Report to Development Permit Panel

File: DP 18-829083

Application by Konic Development Ltd. for a Development Permit at 8291 and

DP 18-829083 - 10-UNIT ARTERIAL ROAD TOWNHOUSE DEVELOPMENT

LEVEL 1 FLOOR PLANS

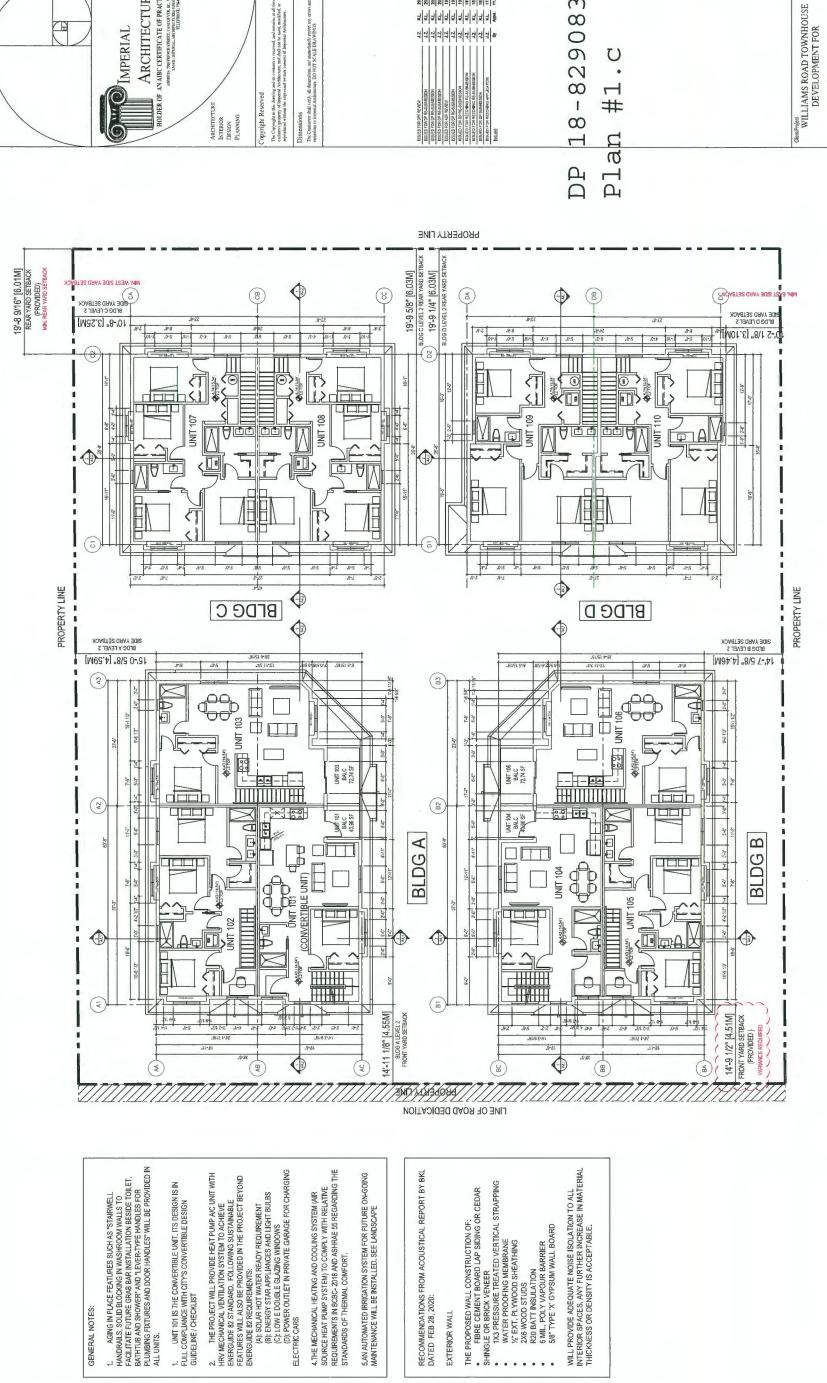
• consider installing ventilation in the garbage room to address potential odour issues especially during summertime;

• concerned about the potential impacts of the garbage room due to its proximity to the balcony in Unit 103 above the garbage room; consider installing mechanical ventilation using carbon filters or synthesizers to mitigate potential odour issues;

A note as "Exhaust fan with duct to roof to be provided to garbage room" was added to ground floor plan. Detailed mechanical design will be provided at BP stage.

A note as "Exhaust fan with duct to roof to be provided to garbage room" was added to ground floor plan. Detailed mechanical design will be provided at BP stage
